SUNDRY NOTICES AND REPORTS ON WELLS (DO NOT USE THIS FORM FOR PROPOSALS TO DRILL OR TO DEEPEN OR PLUG BACK TO A DIFFERENT RESERVOIR. USE "APPLICATION FOR PERMIT" (FORM C-101) FOR SUCH PROPOSALS.)		WELL API NO. 30-015-21639

2. Name of Operator Rubicon Oil & Gas, LLC		6. State Oil & Gas Lease No: 36037
3. Address of Operator 508 W. Wall St. Suite 500 Midland, Texas 79701		7. Lease Name or Unit Agreement Name Overshot State 10

Rubicon proposed to plug and abandon the Overshot State 10 No. 1 -- See attached plugging procedure and well bore diagram

CONDITIONS OF APPROVAL FOR PLUGGING & ABANDONMENT

# Purposed

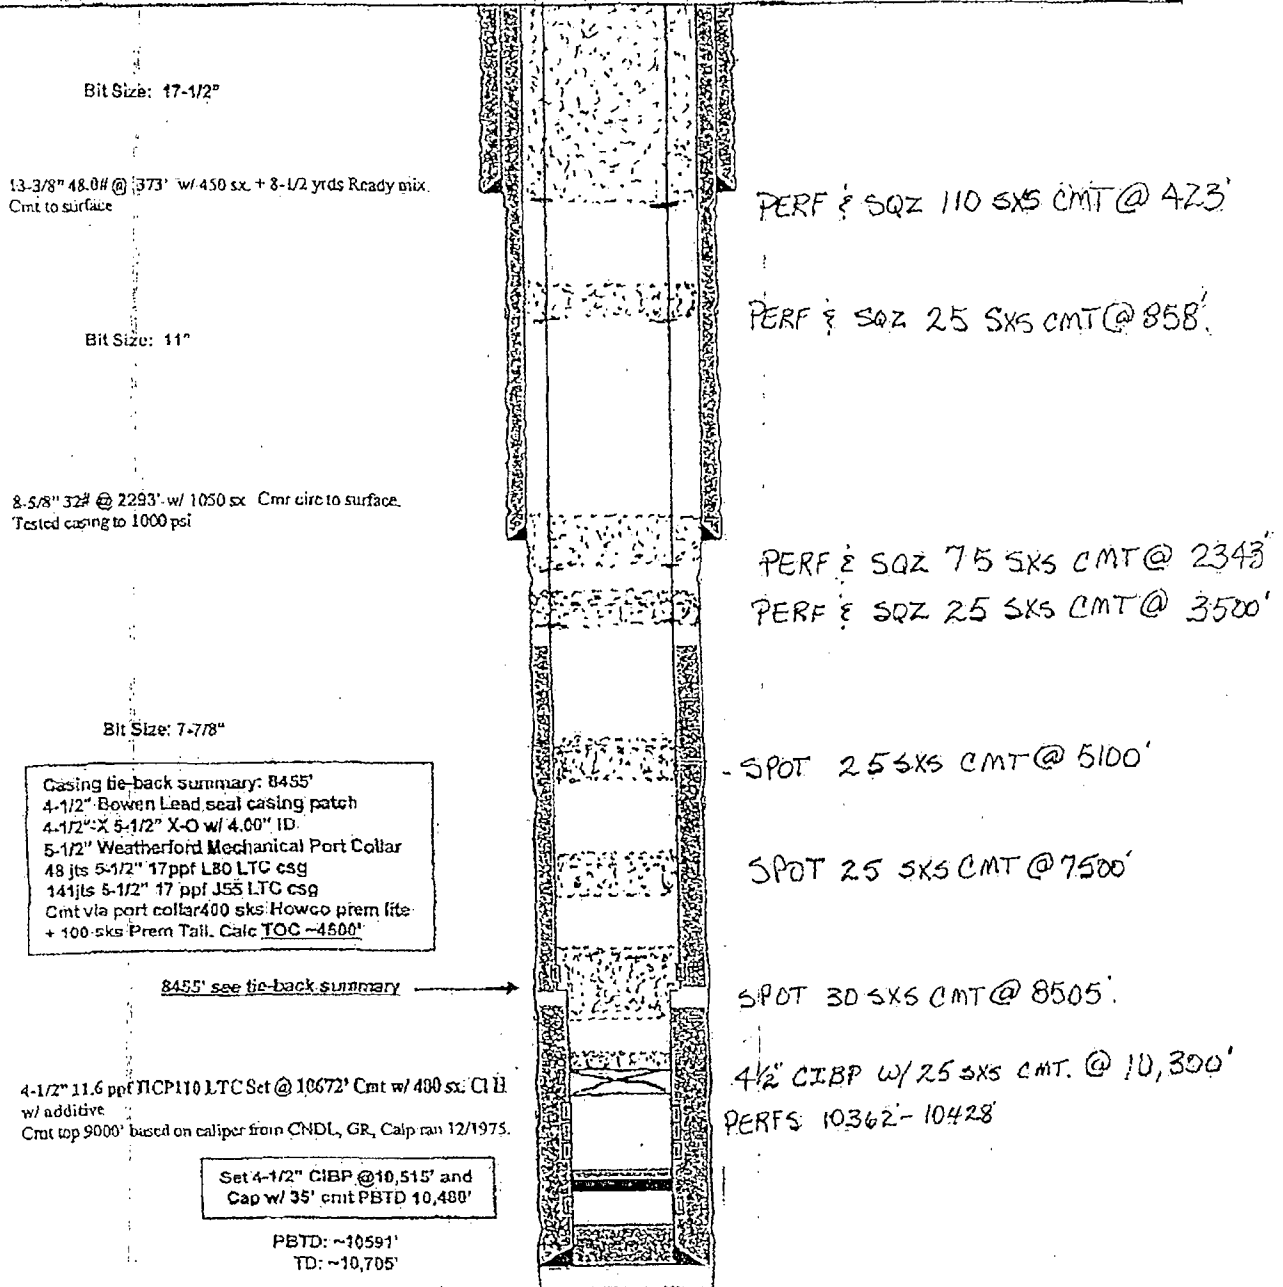
1. Produced water **will not** be used during any part of the plugging & abandonment operation.
2. Notify NMOCD Dist. 2 office at least 24 hrs before beginning work.

3. Closed Loop System is to be used for entire plugging operation. Upon completion, contents of steel pit are to be hauled to a permitted disposal location.

7. Every attempt must be made to clean the well bore out to below the perms, before any plugs can be set, by whatever means possible.
8. Cement Retainers may not be used.

9. Squeeze pressures are not to exceed 500 PSI, unless approval is given by NMOCD.
10. Plugs may be combined after consulting with and getting approval from NMOCD.
11. Minimum WOC time for tag plugs will be 4 Hrs.
